**FINAL DRAINAGE REPORT FOR  
HCD DRILLING  
2601 EAST PLATTE AVENUE  
COLORADO SPRINGS, COLORADO 80916**

July, 2021  
Revised April, 2022

Job No. 1895.00  
PCD Filing No.: MS-21-008

**OUTLET STRUCTURE & MICROPOOL PLAN VIEW**

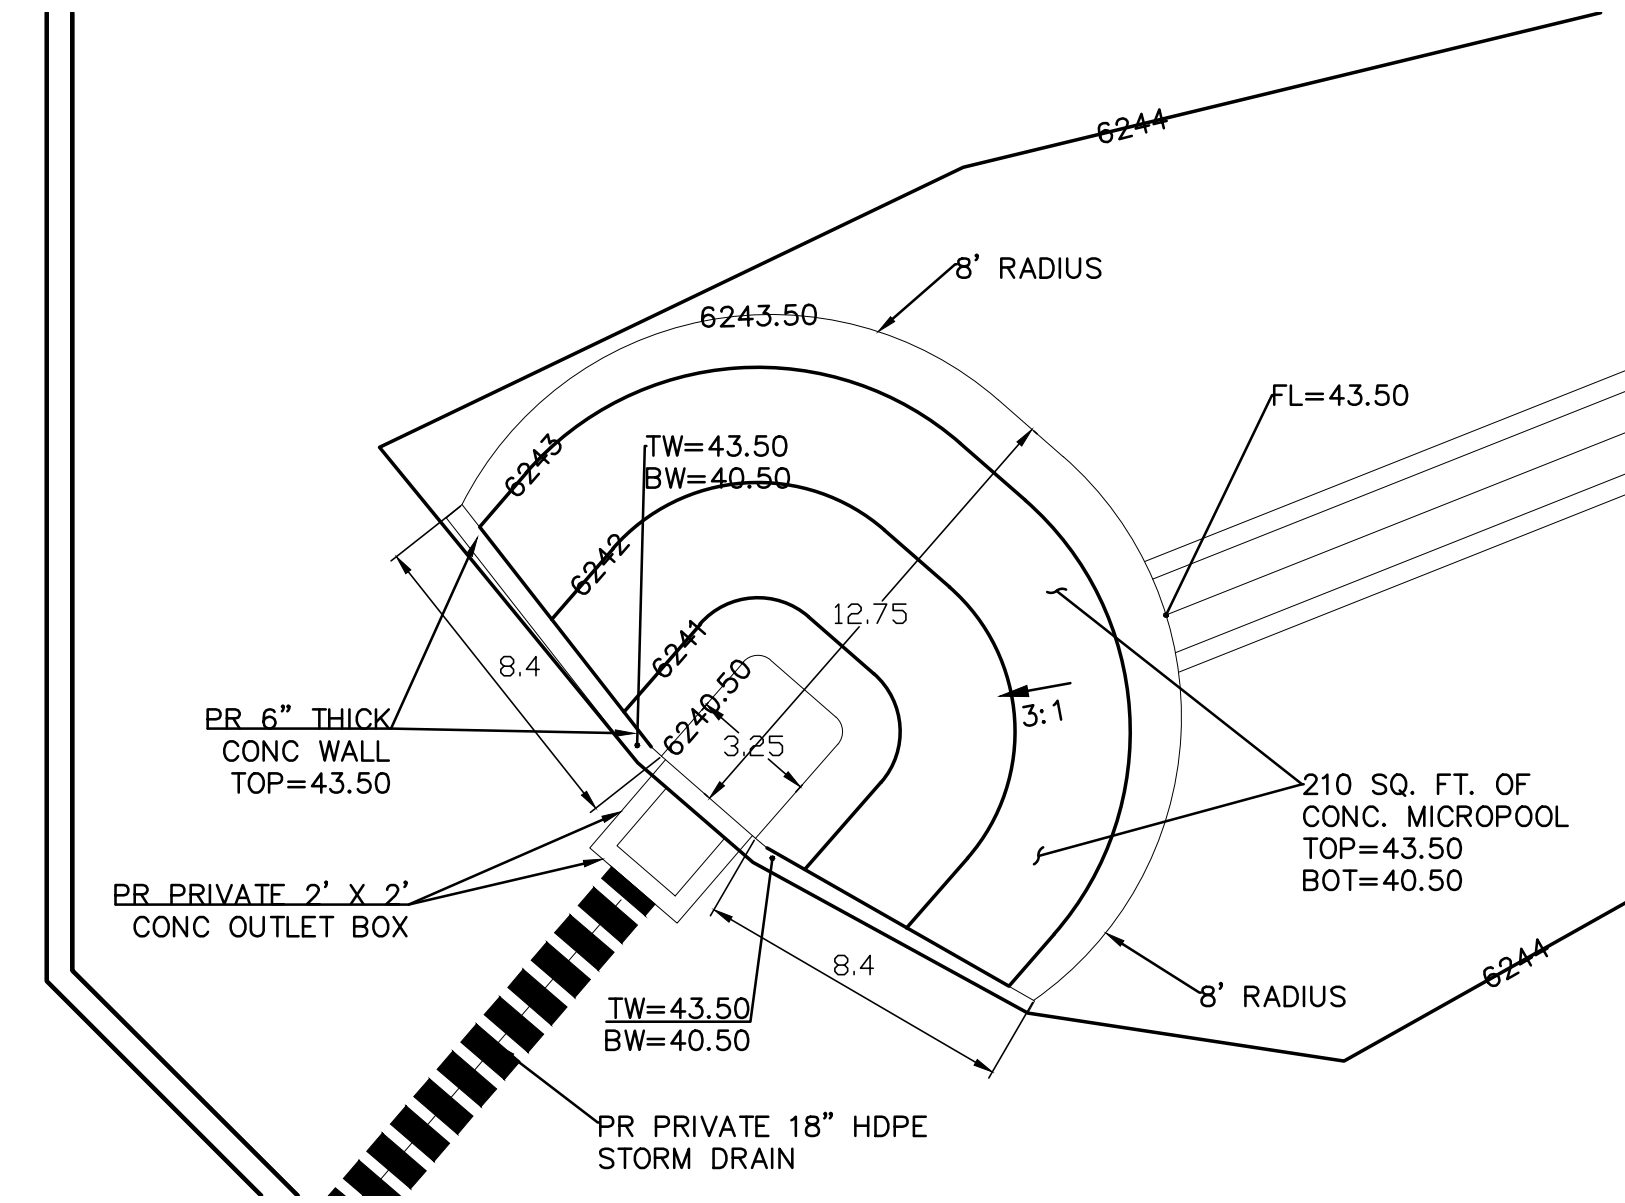
Figure OS-4 not provided on Sheet 4. So no trash rack details were provided.

**CONCRETE FOREBAY DETAIL**

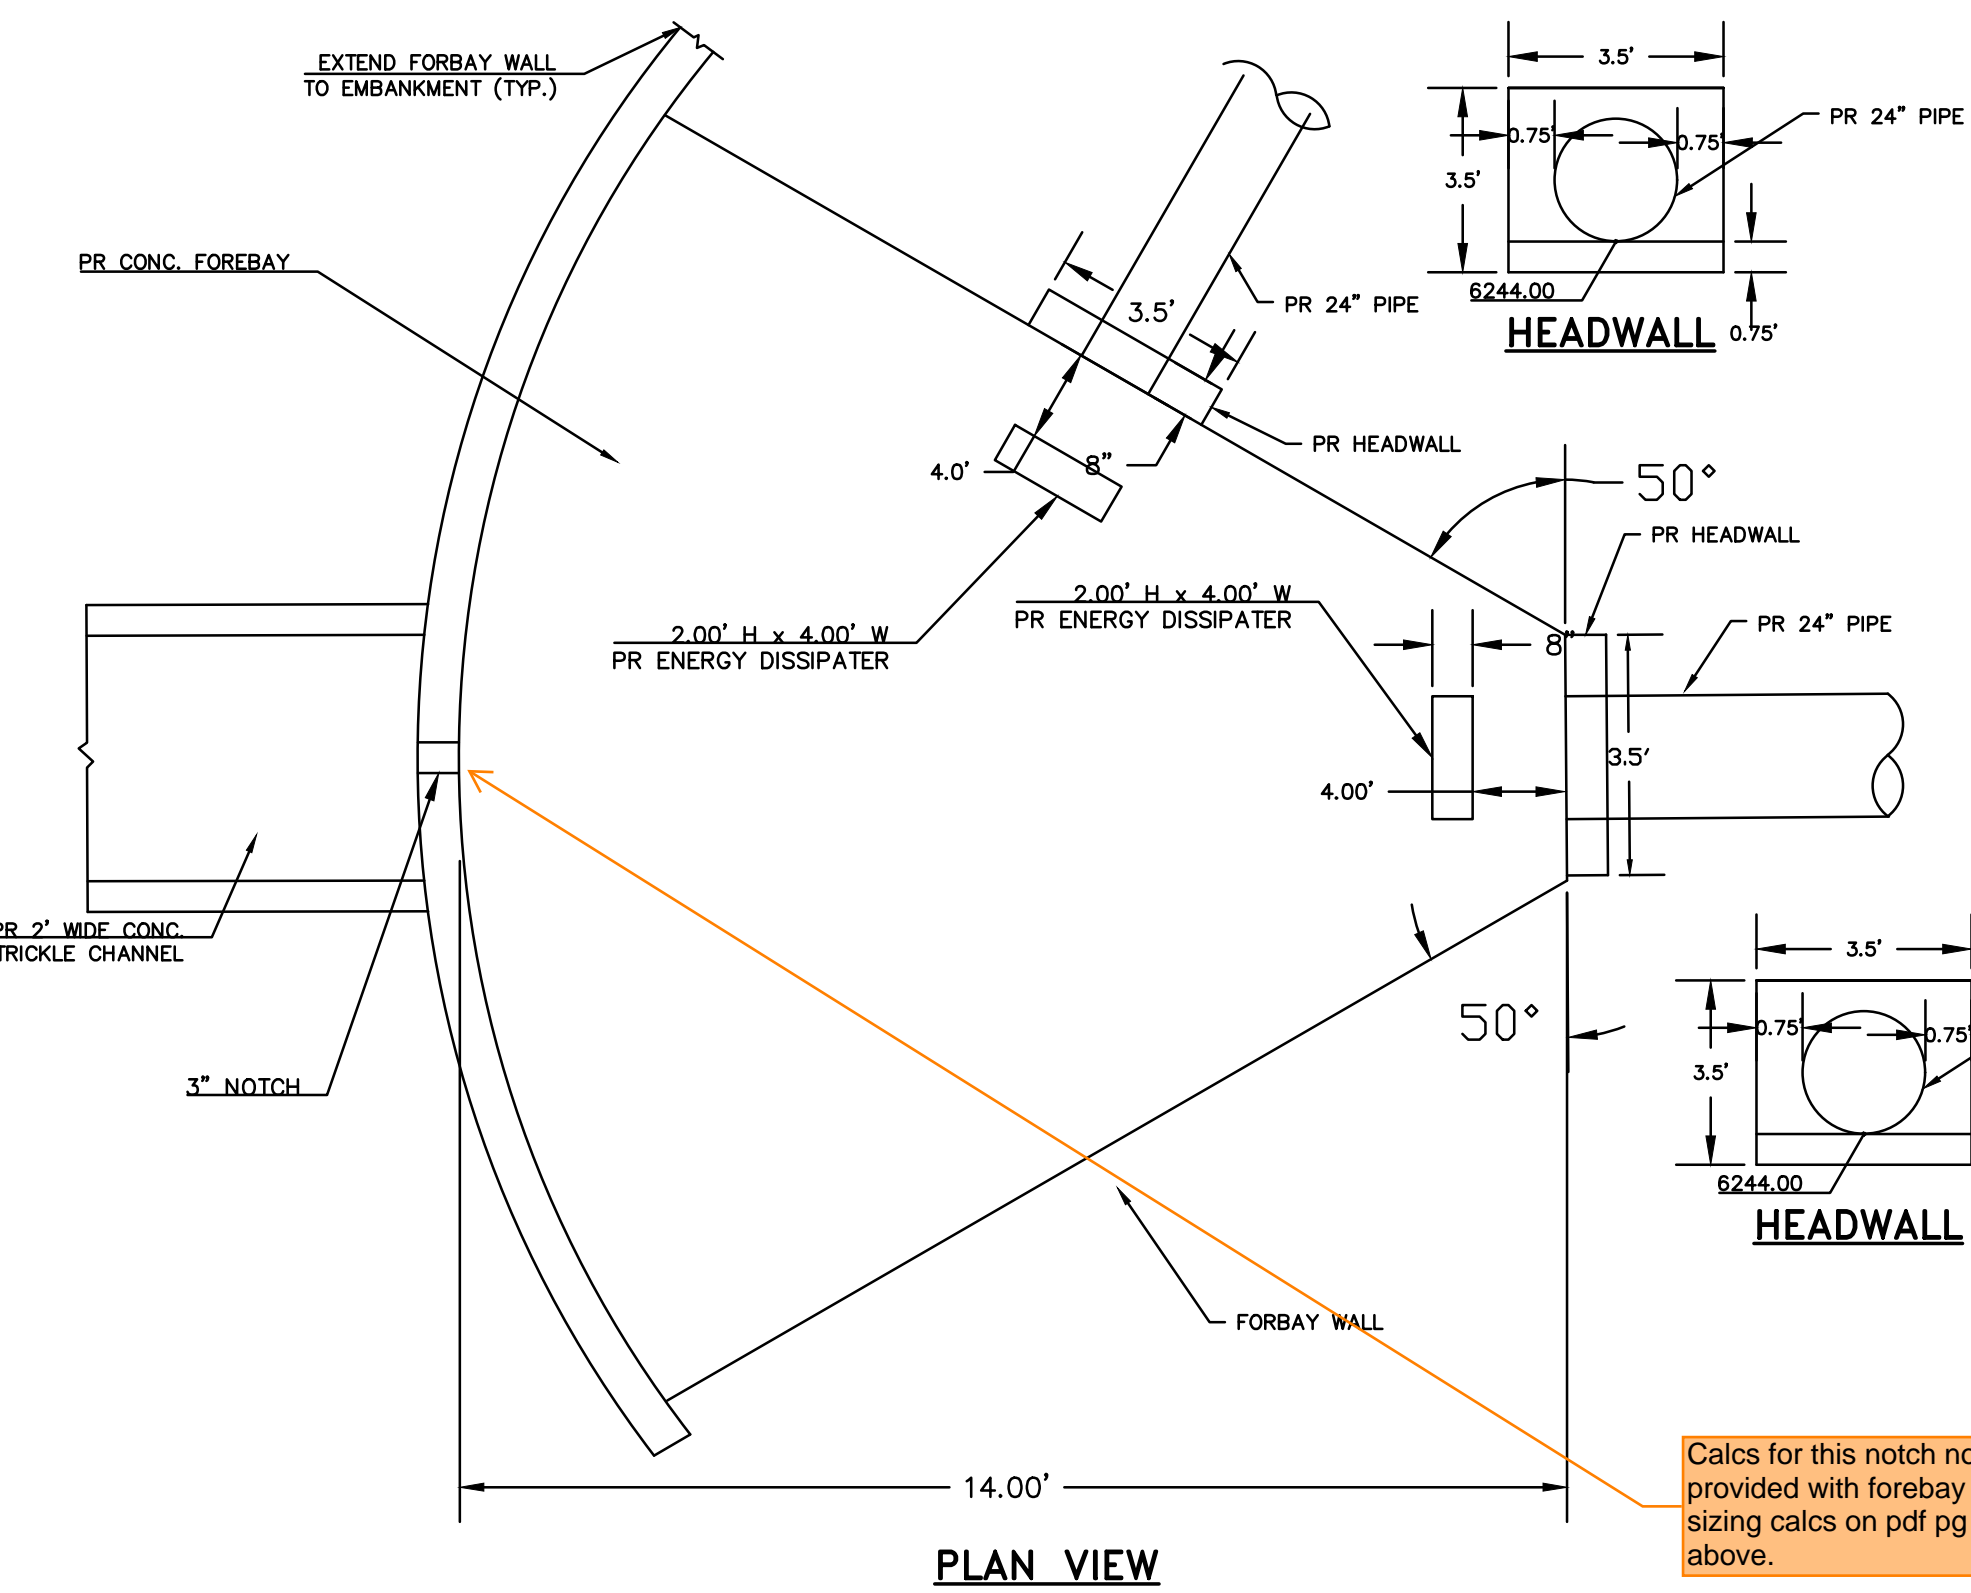
Calcs for this notch not provided with forebay sizing calcs on pdf pg 40 above.

**FULL SPECTRUM EXTENDED DETENTION BASIN DETAIL**

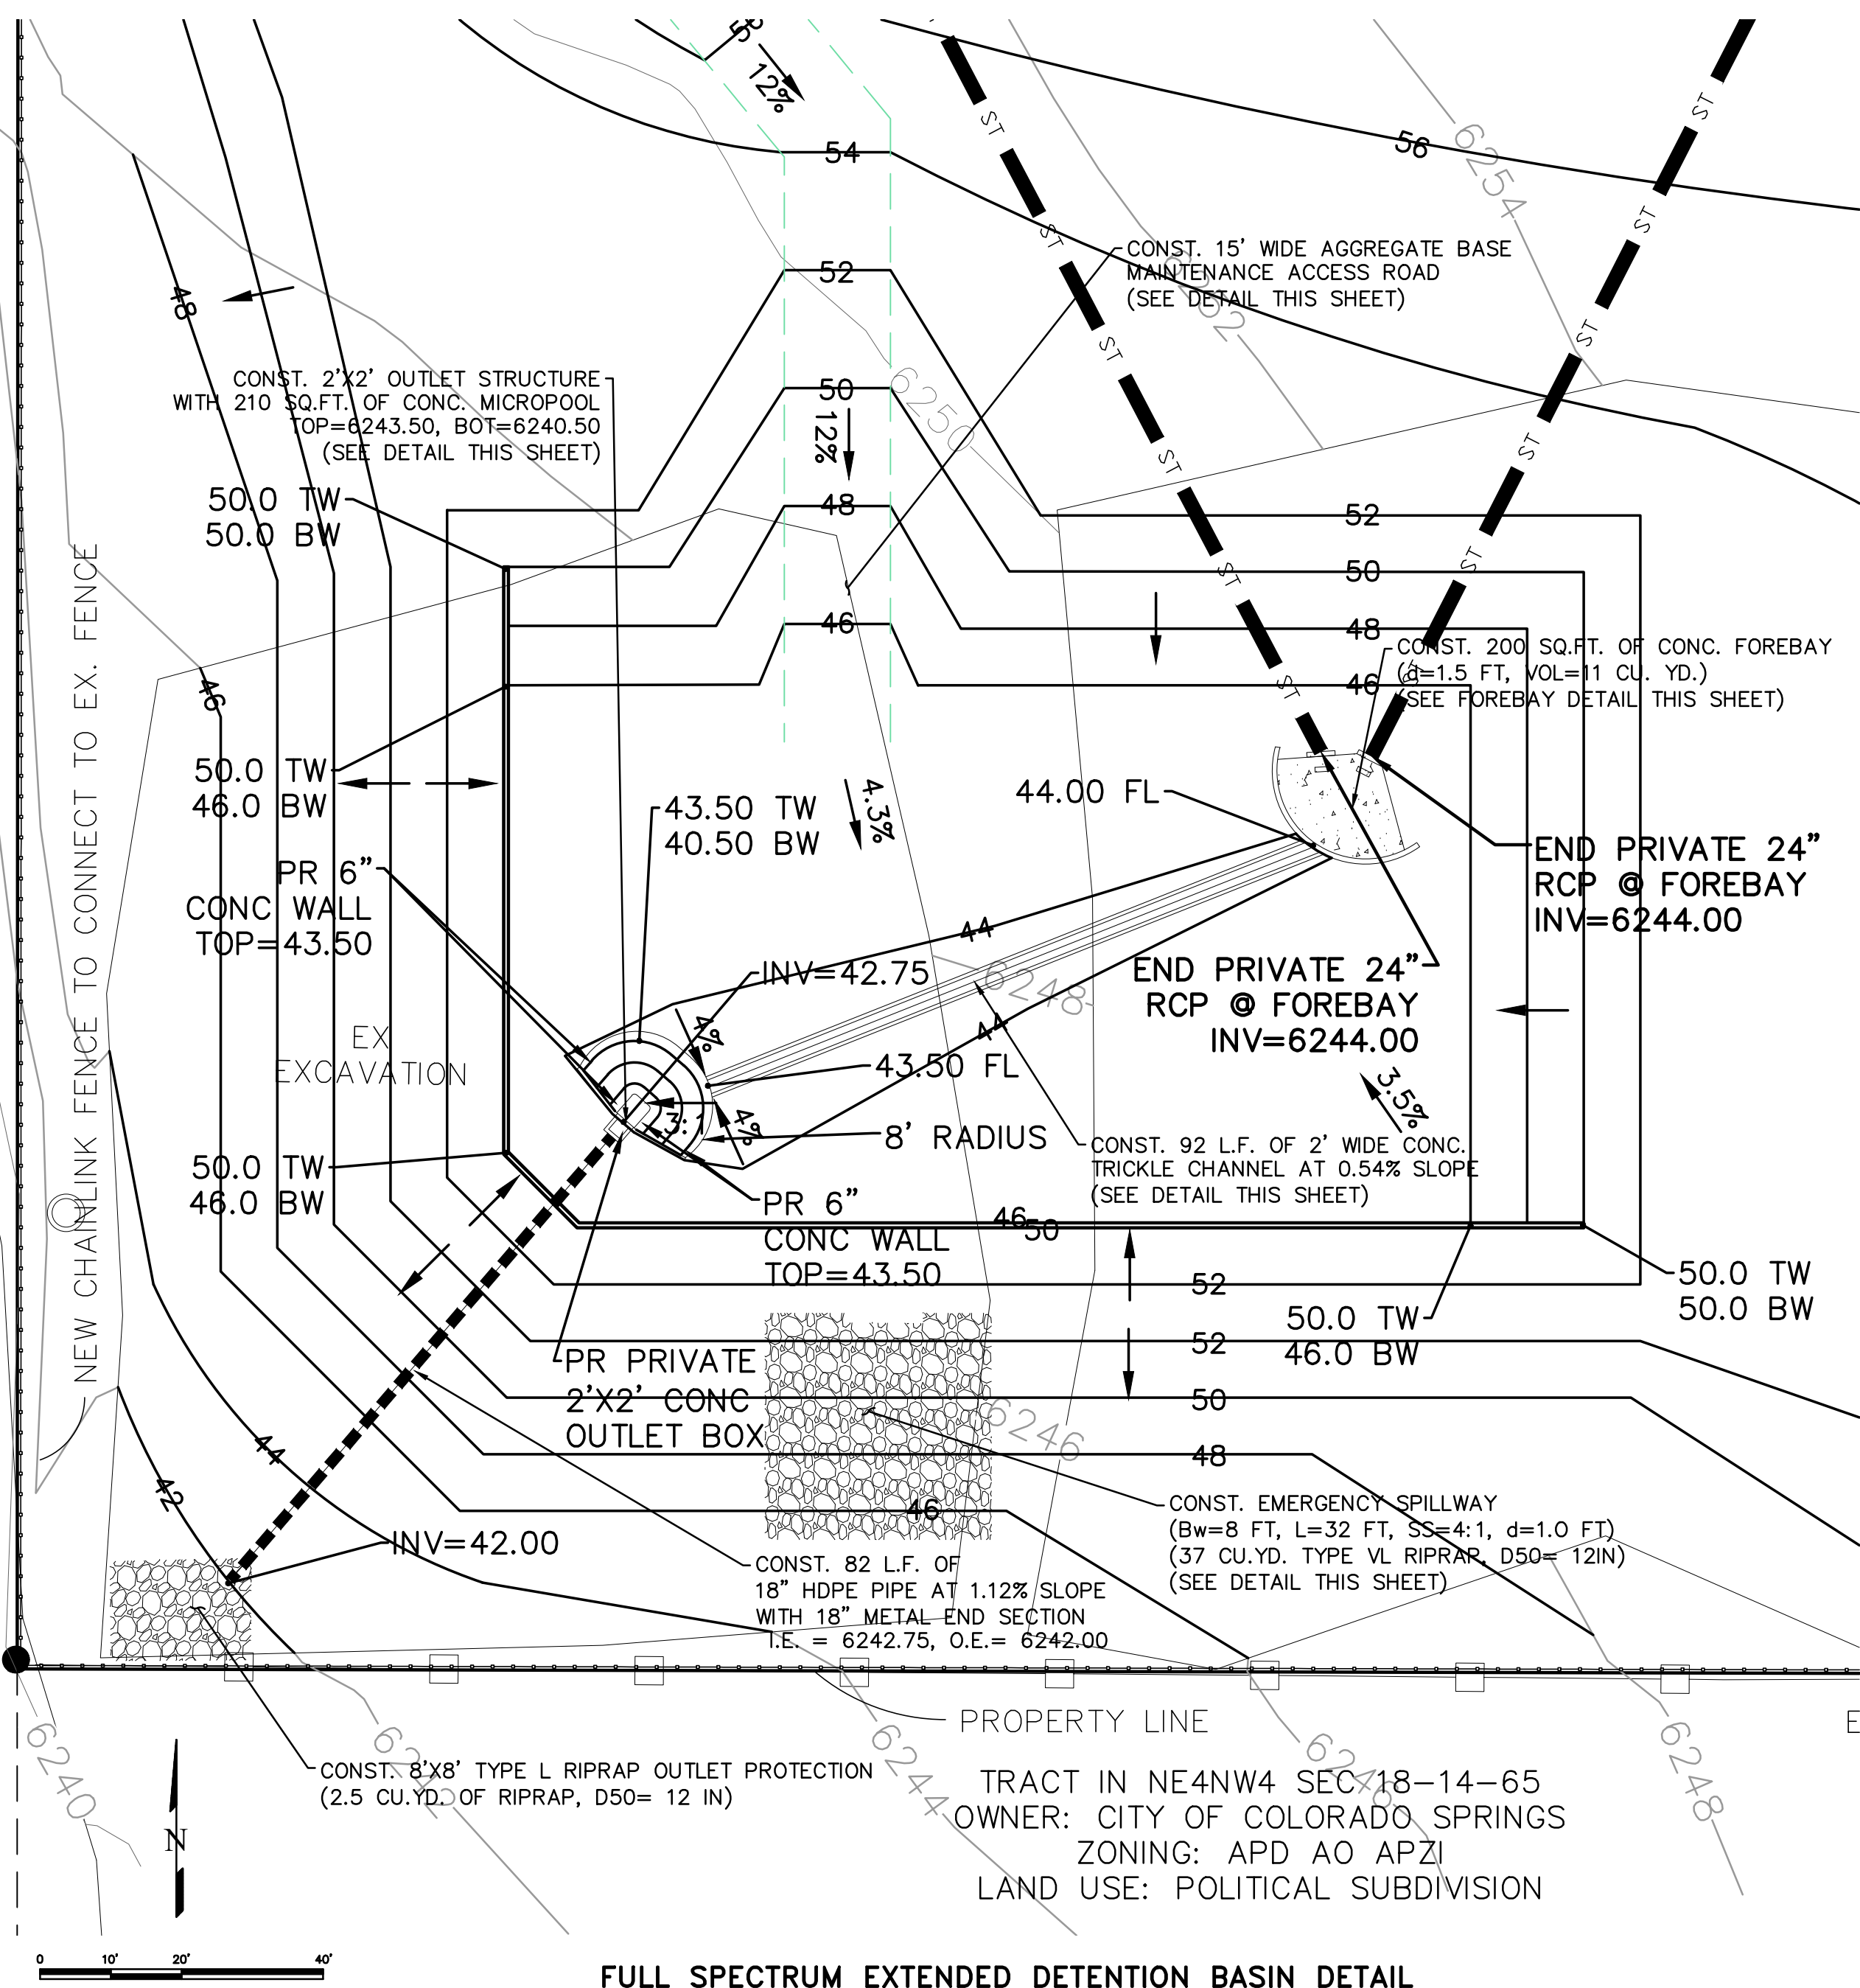
Unresolved Review #1 comment: Include forebay and micropool sizing and well screen calcs with this drainage report. MHFD has the UD-BMP spreadsheet that does these calcs for you.

Review #2 update: Forebay and micropool sizing calcs are provided on pdf pg 40 above. But still missing calcs for forebay notch and well screen. The UD-BMP spreadsheet will do those calcs quickly. You can upload a printout of it to this drainage report.
